SERVICE BULLETIN

N° 139-545

REV. : A - February 16, 2021

ATA 78 - EXHAUST RETROMOD

Figure 3

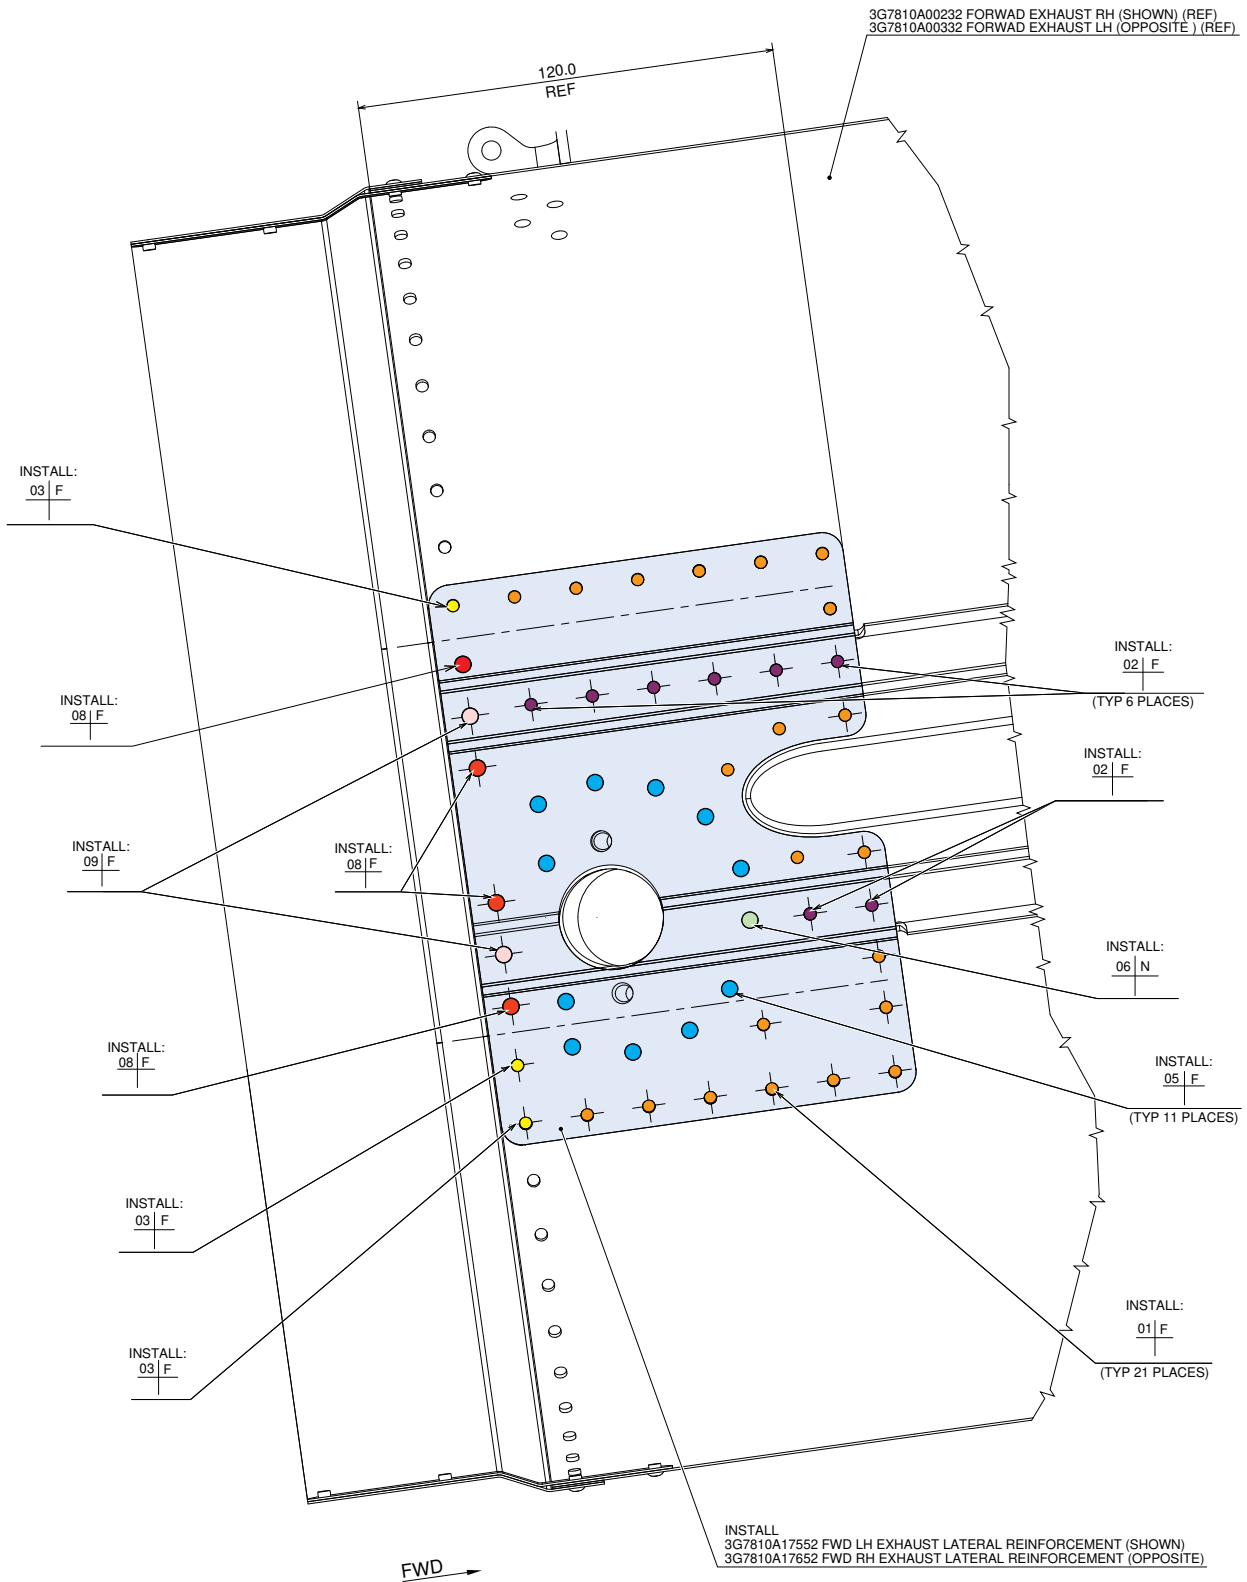
- 5.1 With reference to Figure 3 View B (parts to remove), in the indicated positions, drill out n°11 rivets P/N MS20615-4M5 and rivet P/N MS20615-4M5R to remove oil breather flange LH P/N 3G7810A15951 or oil breather flange RH P/N 3G7810A16051. Retain oil breather flange for later reuse.

- 5.2 With reference to Figure 3 View B (parts to remove), in the indicated positions, drill out n°6 rivets P/N MS20615-4M6 to remove side bracket P/N 3G7810A10751. Retain side bracket for later reuse.

- 5.3 With reference to Figure 3 View B (parts to remove), in the indicated positions, drill out n°2 rivets P/N MS20615-3M4 and rivet P/N MS20615-3M3R.

- 5.4 With reference to Figure 3 View B (parts to remove) and Figure 15, perform the indicated cut-outs on the LH holed stiffener P/N 3G7810A15151 or RH holed stiffener P/N 3G7810A15651.

Figure 4

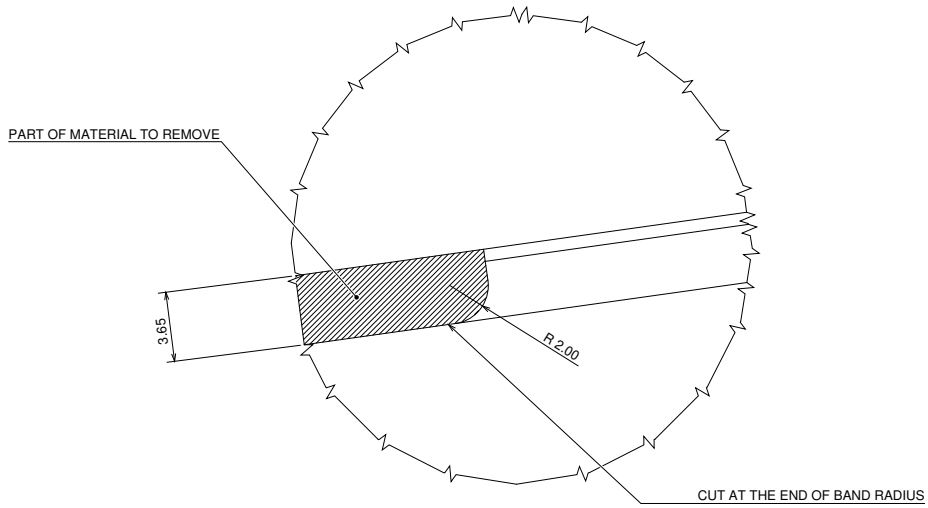
- 5.5 With reference to Figure 4 View B (parts to install), install FWD LH exhaust lateral reinforcement P/N 3G7810A17552 or FWD RH exhaust lateral reinforcement P/N 3G7810A17652 by means of n°21 rivets P/N MS20615-3M3, n°8 rivets P/N MS20615-3M3R and n°3 rivets P/N MS20615-3M4.

- 5.6 With reference to Figure 4 View B (parts to install) and Figure 16 View F, reinstall oil breather flange LH P/N 3G7810A15951 or oil breather flange RH P/N 3G7810A16051 by means of n°11 rivets P/N MS20615-4M5 and rivet P/N MS20615-4M5R.

- 5.7 With reference to Figure 4 View B (parts to install) and Figure 16 View F, reinstall side bracket P/N 3G7810A10751 by means of n°4 rivets P/N MS20615-4M6R and n°2 rivets P/N MS20615-4M7.

Figure 7

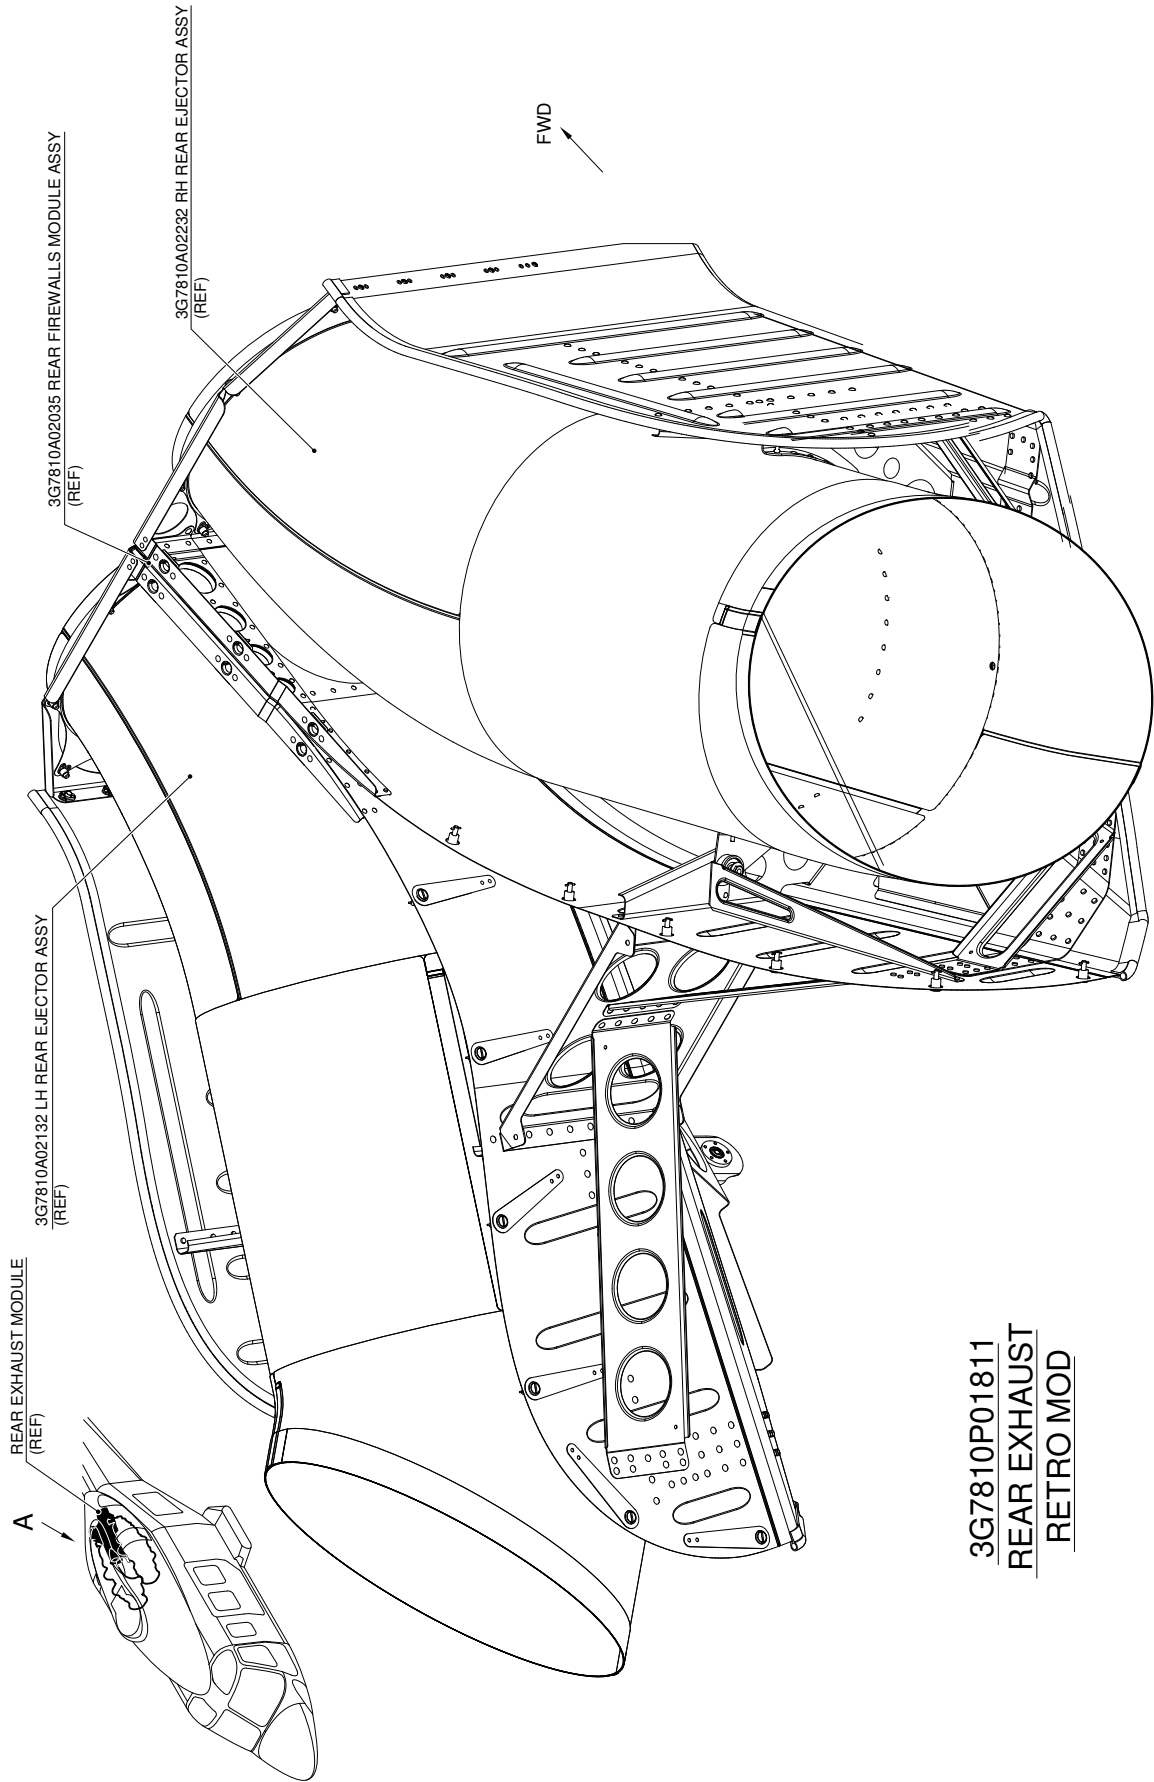
- 5.8 With reference to Figure 7 View G (parts to remove), in the indicated positions, drill out n°8 rivets P/N MS20615-4M5 to remove upper bracket LH P/N 3G7810A10652 or upper bracket RH P/N 3G7810A11452. Retain upper bracket for later reuse.

- 5.9 With reference to Figure 7 View G (parts to remove), in the indicated positions, drill out n°4 rivets P/N NAS1097U3-3, n°2 rivets P/N MS20615-3M4 and n°2 rivets P/N MS20615-3M3 to remove closure plate P/N 3G7810A14851. Discard closure plate.

- 5.10 With reference to Figure 7 View G (parts to remove), in the indicated positions, drill out n°10 rivets P/N MS20615-3M3R.
- 5.11 With reference to Figure 7 View G (parts to install), install FWD LH exhaust upper reinforcement P/N 3G7810A17351 or FWD RH exhaust upper reinforcement P/N 3G7810A17451 by means of n°34 rivets P/N MS20615-3M3, n°12 rivets P/N MS20615-3M4 and n°4 rivets P/N NAS1097U3-3.

- 5.12 With reference to Figure 7 View G (parts to install) and Figure 16 View F, reinstall upper bracket LH P/N 3G7810A10652 or upper bracket RH P/N 3G7810A11452 by means of n°8 rivets P/N MS20615-4M5R.
6. Repeat step 5 for the symmetric side.
 7. With reference to Figure 2, remark FWD exhaust LH P/N 3G7810A00332 as "P/N 3G7810A00332 REV.B" by means of ink marking rubber stamp method.
 8. With reference to Figure 2, remark FWD exhaust RH P/N 3G7810A00232 as "P/N 3G7810A00232 REV.B" by means of ink marking rubber stamp method.
 9. In accordance with AMP DM 39-E-78-10-04-00A-720A-A and DM 39-E-78-10-06-00A-720A-A and with reference to Figure 1, reinstall FWD exhaust LH P/N 3G7810A00332 and FWD exhaust RH P/N 3G7810A00232 on the helicopter.

Figure 12

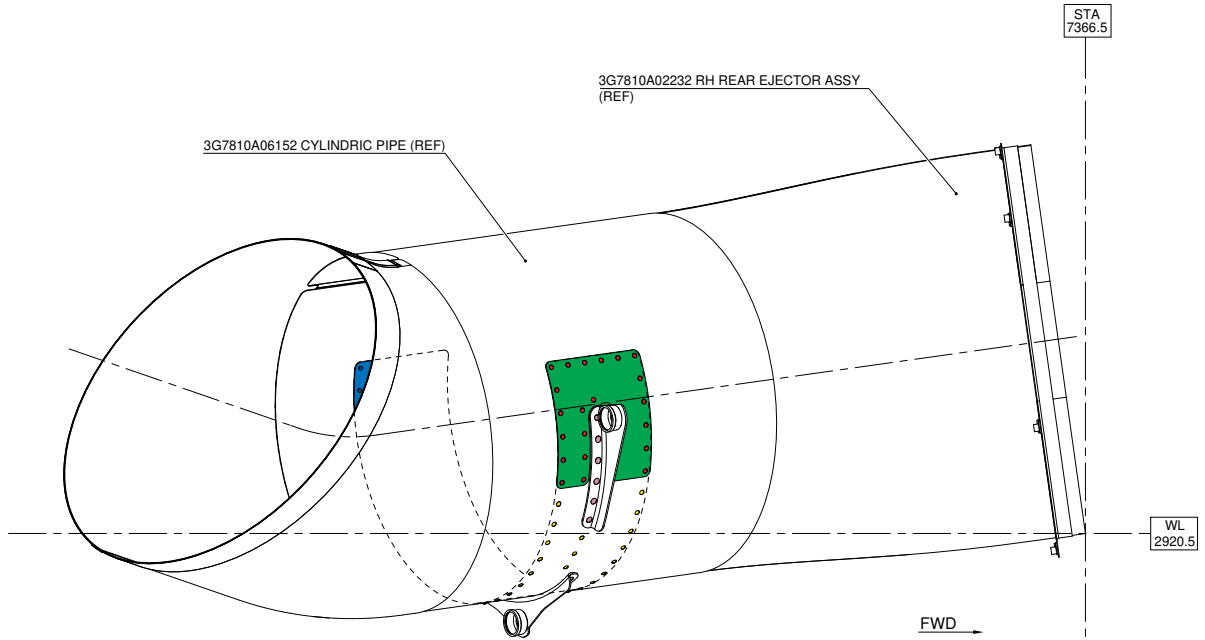
- 5.4 With reference to Figure 12 View E (LH) or to Figure 15 View N (RH), using reinforcement with n°25 pilot holes as a template, drill n°25 rivet holes $\varnothing 2.36 \div 2.62$ through the reinforcement and the cylindrical pipe.

- 5.5 With reference to Figure 12 Section F-F, drill out the existing rivets from the cylindrical pipe P/N 3G7810A06152 to remove external cup assy exhaust LH P/N 3G7810A14331, central cup assy exhaust P/N 3G7810A16431 and internal cup assy exhaust LH P/N 3G7810A14131. Retain cup assemblies for later reuse.

Figure 17

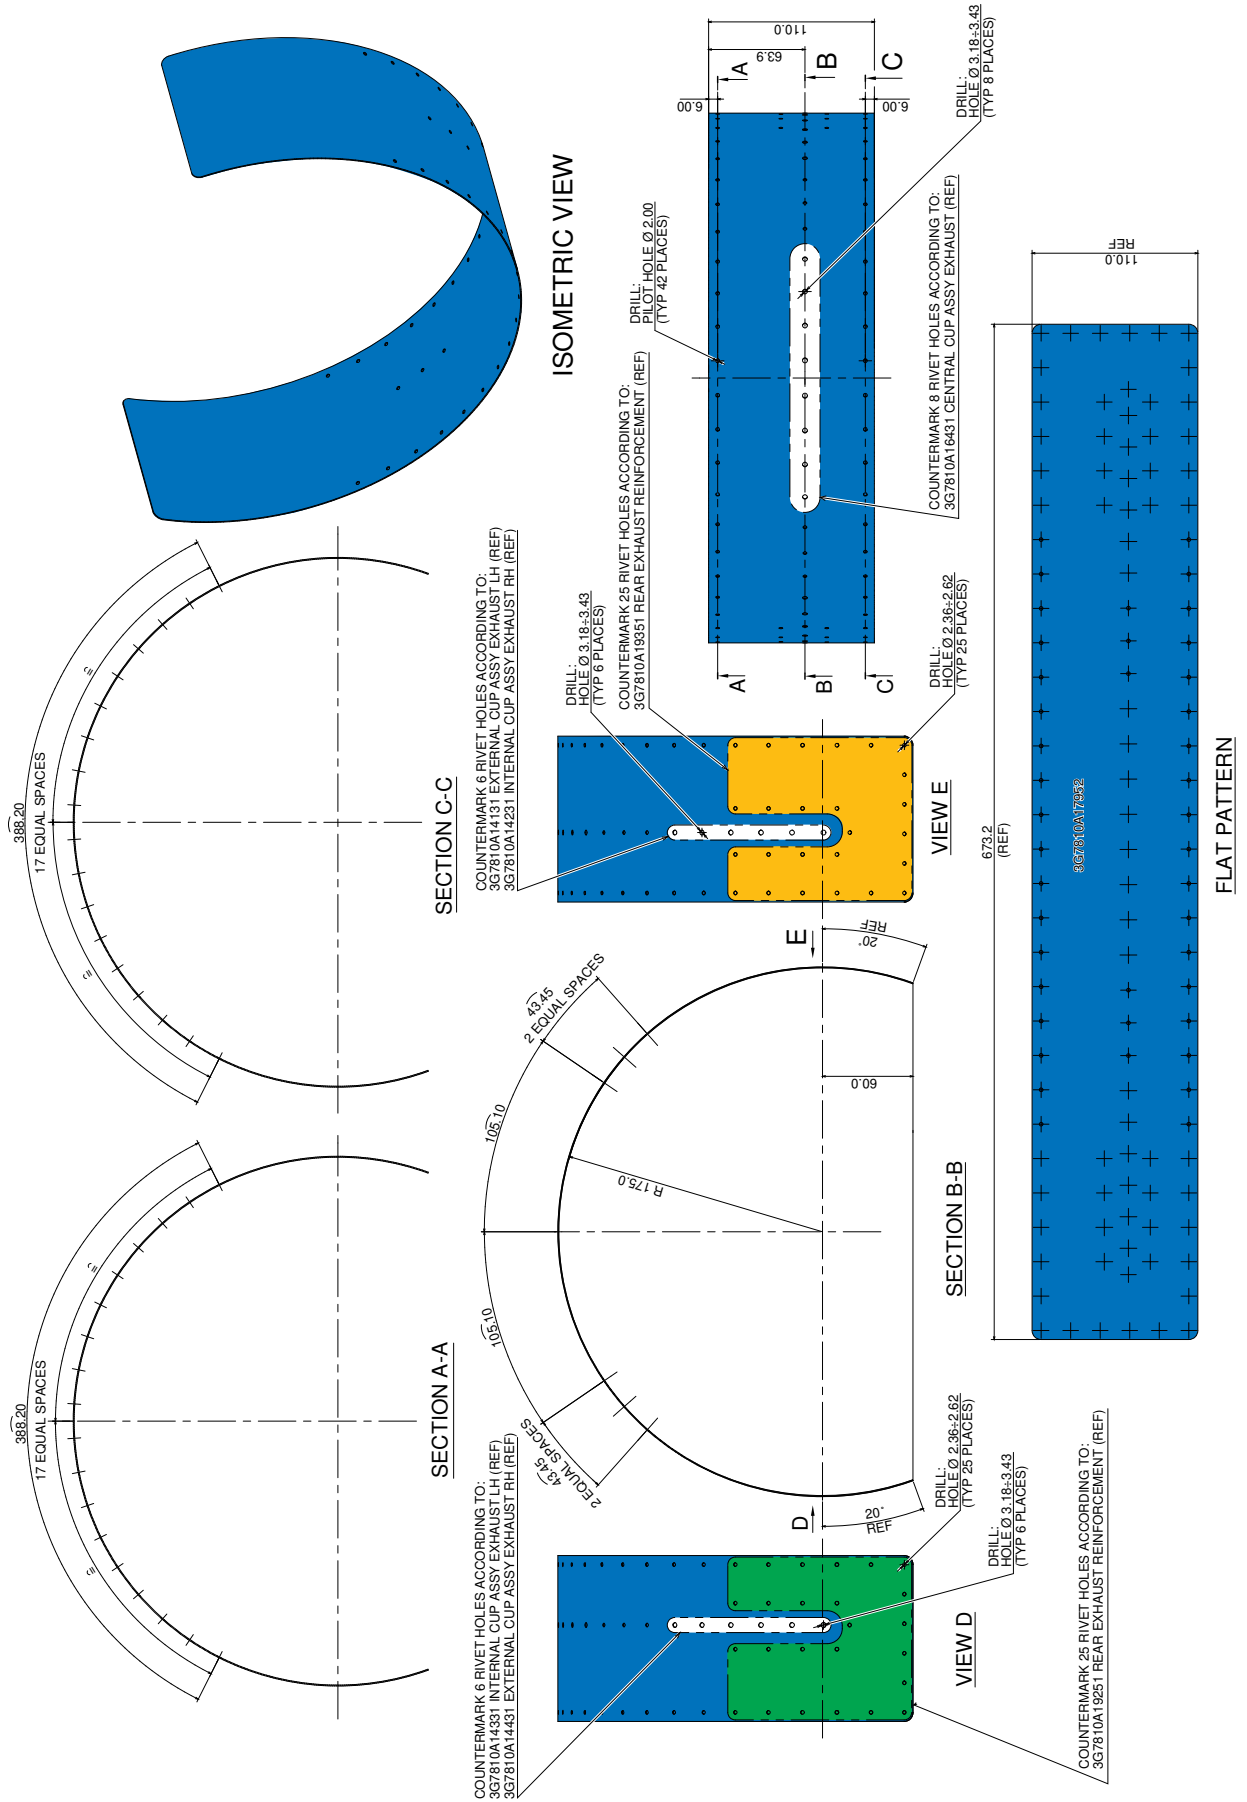
- 5.10 With reference to Figure 17, drill n°42 pilot holes $\varnothing 2.00$ in the indicated positions on the rear exhaust reinforcement P/N 3G7810A17952.
- 5.11 With reference to Figure 9 Bottom View, temporarily locate the rear exhaust reinforcement P/N 3G7810A17952 and countermark n° 42 rivet holes on the cylindrical pipe P/N 3G7810A06152.
- 5.12 With reference to Figure 9 Bottom View, drill n°42 rivet holes $\varnothing 2.36 \div 2.62$ in the previously marked positions on the cylindrical pipe.
- 5.13 With reference to Figure 9 Bottom View, Figure 11 View D and Figure 12 View E, install rear exhaust reinforcements P/N 3G7810A17952, P/N 3G7810A19351 and P/N 3G7810A19251 by means of n°42 rivets P/N MS20615-3M3 and n°50 rivets P/N MS20615-3M3R.
